CPP Project 6029

Subject: Wind Engineering – Building C3, Barangaroo South

Please find herein comments regarding the impact of the architectural changes to the Barangaroo South development on the pedestrian level wind conditions. The drawings prepared for this Planning Application No. MP11\_0044 S75W Mod 2 dated 13 September 2013 have been reviewed and assessed from an environmental wind perspective at ground level. The only relevant geometric changes are the re-orientation of Globe Street, with the corresponding change in plan form of Buildings R11, R2, R3, C1, C3, and C8, Figure 1, and the removal of mid-rise building C7, Figure 2. The heights of the amended buildings are similar.

Figure 1: Ground plan of existing Mod 4 (L) and proposed Mod 6 (R) configurations

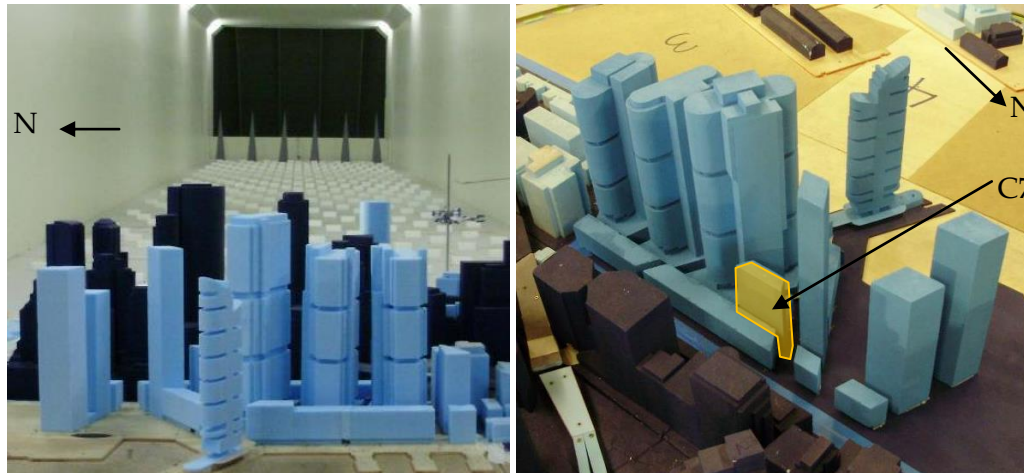
From a comfort criterion perspective the wind conditions around the site all met the pedestrian walking criterion, Figure 3, except around the base of the hotel protruding into the harbour. From a pedestrian level wind comfort perspective, the most important change from the Mod 4 to Mod 6 geometry is the increase in size of the Building C3 podium, marked in red in Figure 3. This increase in size is expected to improve wind conditions to the north of Building C3 and along Shelley Lane and Globe Street, by redirecting downwash from reaching ground level. The forming of a regular street grid pattern, particularly opening Globe Street to the west, will increase the ground level wind speed and the channelling of wind. Winds from the west will be channelled along Globe Street to the north of Building C3 causing windy conditions across Hickson Road. The rising topography to the east of the site and the lack of a continuation of the flow path across Hickson Road will ameliorate this condition and wind conditions are expected to remain suitable for pedestrian walking hence acceptable for the intended use of the space.

Figure 3: Wind climate results for the Mod 4 configuration (T) and curved towers and realignment of Globe Street(B)

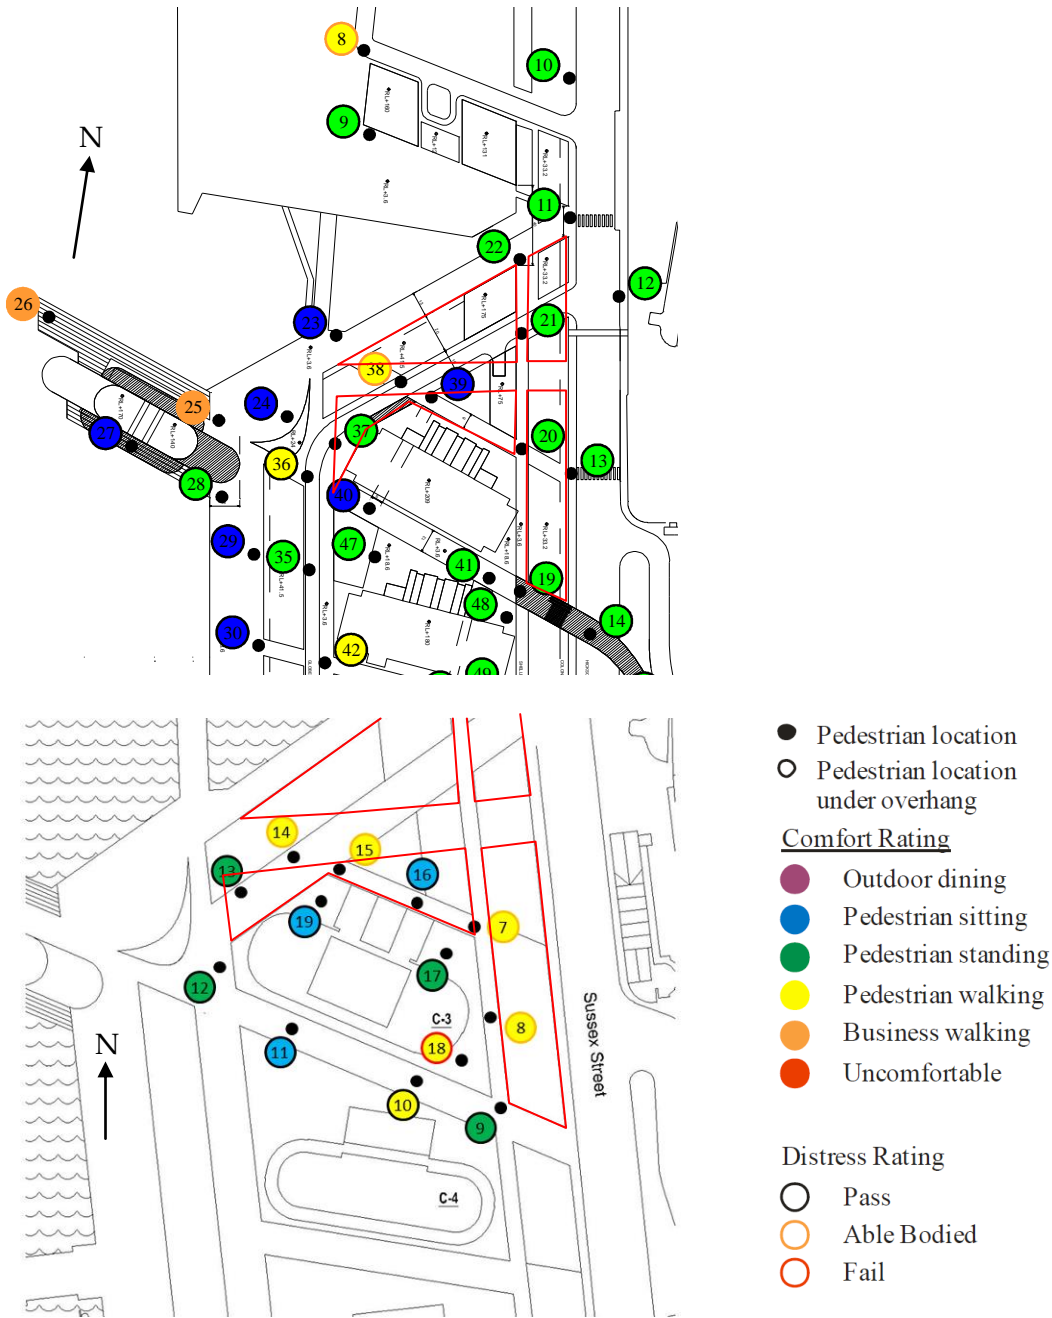
From a pedestrian distress perspective, apart from in the vicinity of the exposed hotel, there were five locations around the site that were classified as acceptable for 'able-bodied' pedestrians only; to the north-west of Building 4 (Location 8, Figure 3(T)), on Globe Street to the north of Building C3 (Location 38, Figure 3(T), and Locations 14 and 15, Figure 3(B)), and on Shelley Lane to the east of Building C3 (Locations 7 and 8, Figure 3(B)). Exceedances were marginal, with a twice per annum mean wind speed about 15.5 m/s compared with the criterion level of 15 m/s, Figure 5, except Locations 8

and 38 with the sharp-edged towers, and Location 7 with the curved towers, which had a wind speed between 17.6 and 18.4 m/s.

Figure 4: Directional results in the Mod 4 configuration with sharp-edged tower

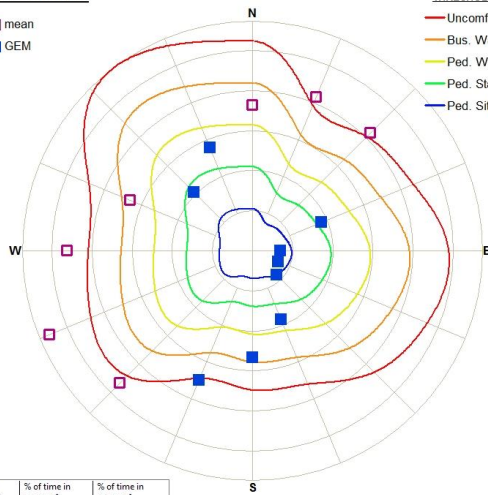
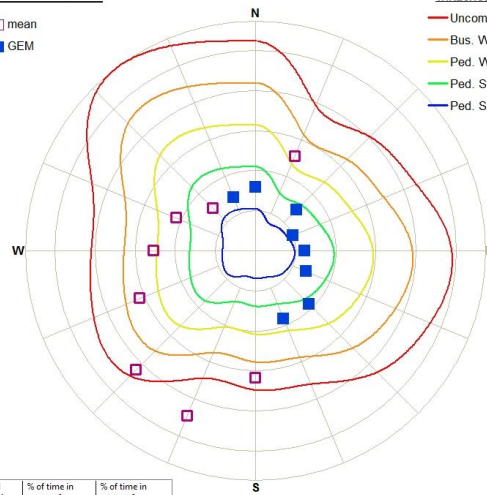
It is evident from Figure 4 that the locations are impacted by winds from the south-west and to a lesser extent from the north-east. The wind conditions at Location 8 are governed by downwash from Building R4 and the proposed changes to the buildings to the south will have negligible impact on the wind climate in this area being governed by the geometry and orientation of Building R4. Winds conditions at Location 38 are expected to improve with the increase in Building C3 podium size by redirecting

downwash away from reaching ground level for critical winds from the south-south-west.

Figure 5: Directional results in the Mod 4 configuration with curved towers

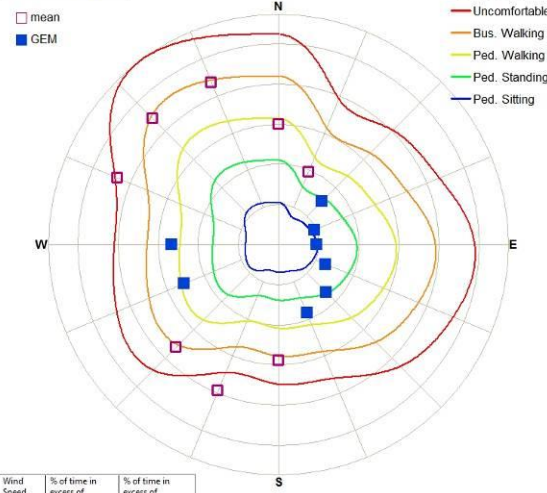
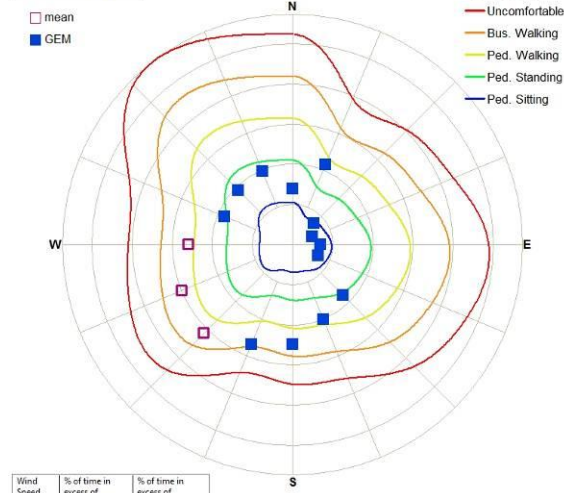
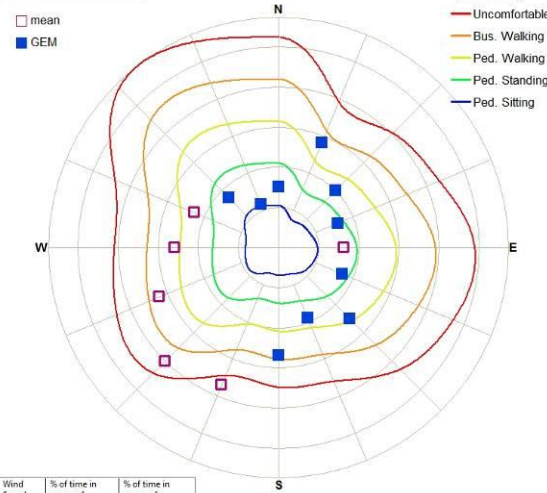
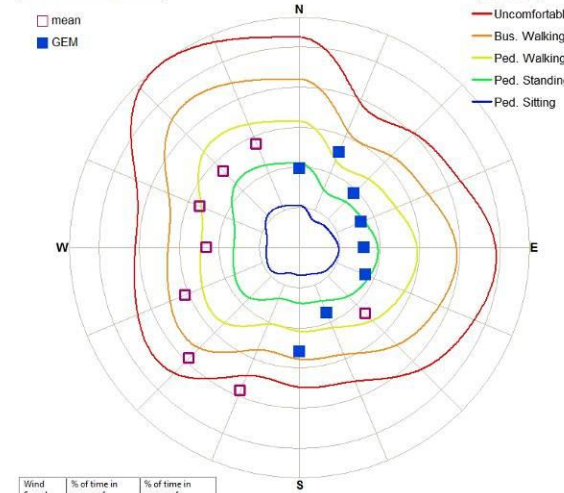
It is evident from Figure 5 that Location 7, on Shelley Lane, was impacted by winds from the south-west and north-west quadrants. Both these wind directions induce downwash from Building C3 at this location. Winds from the south-west are channelled between Buildings C3, C4, and the hotel on the peninsula and brought to ground level by the massing of the tall buildings. Winds from the north-west are brought to ground level by the massing of Building C3. With the increase in podium size to the north of Building C3, a portion of this downwash will be redirected away from reaching ground level and will pass over the roofs of Building C1/C8. The re-direction of flow is expected to improve the wind conditions in this area.

Locations 14 and 15 marginally exceed the distress criterion and are classified as suitable for 'able bodied' pedestrians. The conditions are caused by strong winds from the south-south-west, Figure 5. These conditions are calmer than Location 38 in Figure 4 caused to a large extent by the curved ends of the towers, but the flow is still accelerated between the hotel and the Building C3 and C4. The increase in size of podium to the north-west of Building C3 and to the south of R3, is expected to improve the wind conditions in this area.
